Decentralized Wastewater Management Port Blair Visit Report and Recommendations

National Institute of Urban Affairs & Ecosan Services Foundation August 2019

The report is prepared after a visit by NIUA team from 23-25th July 2019, to the city of Port Blair and a review of the Sewerage Plan prepared by WAPCOS.

FIGURE 2: GOOGLE TERRAIN MAP REPRESENTING THE LOCATIONS OF POINTS VISITED IN ZONE A

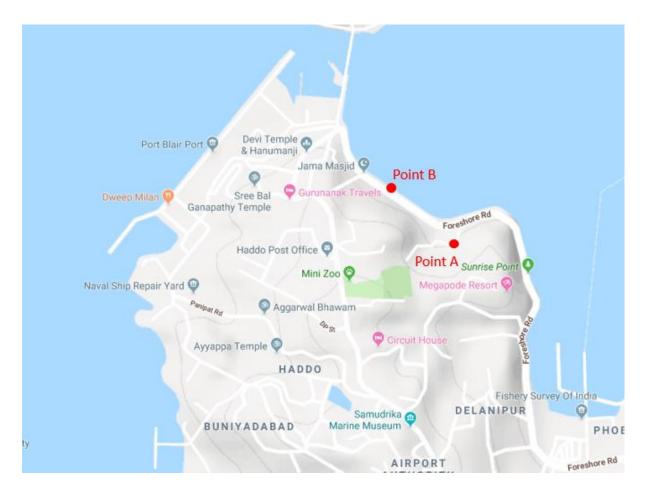
At point A the households discharging septic tank effluent and grey water were observed. It was also observed that the location of the toilets and the width of the road is not favourable for laying of sewerage pipes and other appurtenances such as manholes.

The network of storm water drains consisting of small and big drains convey the wastewater to the main road where it crosses and finally meets the sea. Challenges and issues observed were,

- The solid waste was dumped into the storm water drains and was going to the sea.
- Laying of gravity sewers will be difficult and pose difficulties since at most places the road either the top slab over the drain or laid in concrete.

FIGURE 6: GOOGLE TERRAIN MAP REPRESENTING THE LOCATIONS OF POINTS VISITED IN ZONE B

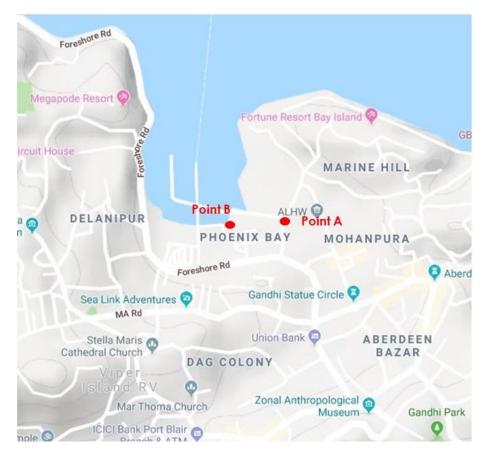
At point A the households, institutes discharging septic tank effluent and grey water were observed at a bigger drain. The area covers households, commercial or market areas and restaurants which discharges their wastewater into the drains directly. The point A has the location of pumping station as proposed in the DPR.

The network of storm water drains consisting of small and big drains convey the wastewater to the main road where it crosses and finally meets the sea at the fisheries jetty (Point B). Challenges and issues observed were,

FIGURE 17: GOOGLE TERRAIN MAP REPRESENTING THE LOCATIONS OF POINTS VISITED IN ZONE I

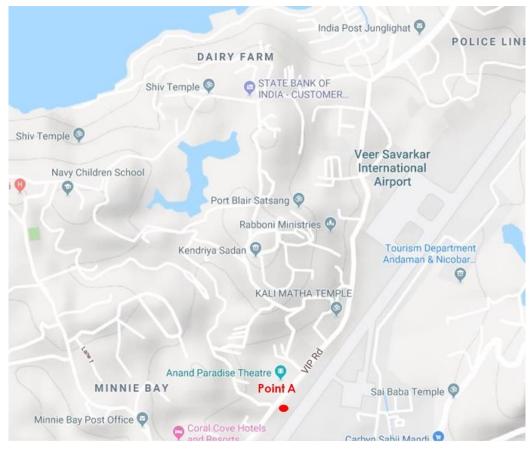
Visit to Zone I covers the location of pumping station near the airport wall. Currently, the wastewater conveying through minor and major storm water drains connects to another bigger storm water drain flowing from the other side of the airport.

As per the sewerage DPR, the sewage in the Zone I will have to be pumped three times before it reaches the 15 MLD STP. Hence it is recommended that the STP should be set up for the zone separately.

FIGURE 20: GOOGLE TERRAIN MAP REPRESENTING THE LOCATIONS OF POINTS VISITED IN ZONE M

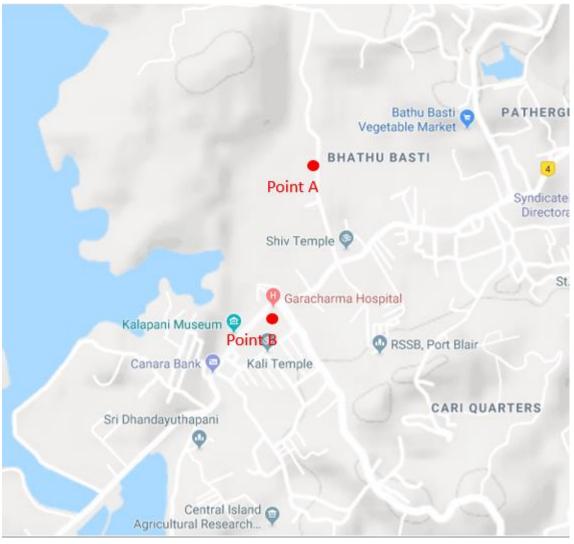
At Point A, the location of proposed decentralised STP was observed. It is located on hill region which covers sparsely populated section of Zone M. The second Point B of pumping station has located near the district hospital.

The key challenges in this zone is its distance from the 15 MLD STP and its undulating nature. Since, suitable land was not available for pumping station at the lowest level of the sewerage system, it has been shifted to the point B where the difference in the level of the pumping station and level of the sump well will be significant.

The sewage from this zone will be pumped at least three times before it reaches the STP. Hence, it is recommended that an appropriate piece of land should be identified and a decentralized STP should be constructed for this zone.

FIGURE 23: GOOGLE TERRAIN MAP REPRESENTING THE LOCATIONS OF POINTS VISITED IN ZONE K AND G

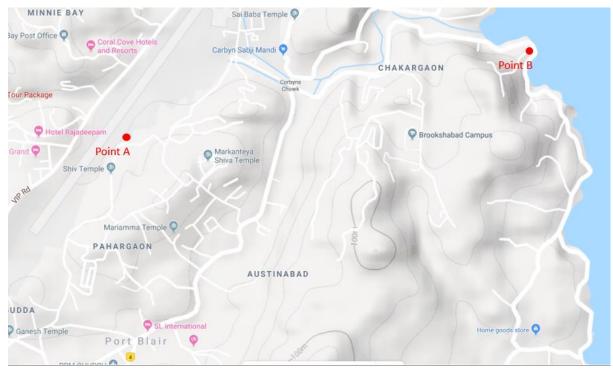
Two locations were visited in these zones. The Point A represents approximate location of the decentralized STP. However, looking closely into the levels of the sewer pipes, there seems to be some discrepancy with the delineation of the zone.

Due to the recent development, the levels of the road might have changed significantly. The same can be observed with the sewerage map produced by WAPCOS. The length of the air strip is shown to be quite small and the location of the STP is to the south of the air strip. However, through the google map it can be seen that the actual location of the STP is to the east of the airstrip.

The other location visited was site for the 15 MLD STP, which is situated on top of the hill. The location was chosen since, adequate area was not available anywhere else. However, if load from Zone E, I, J and M can be reduced then considerably smaller area will be required.
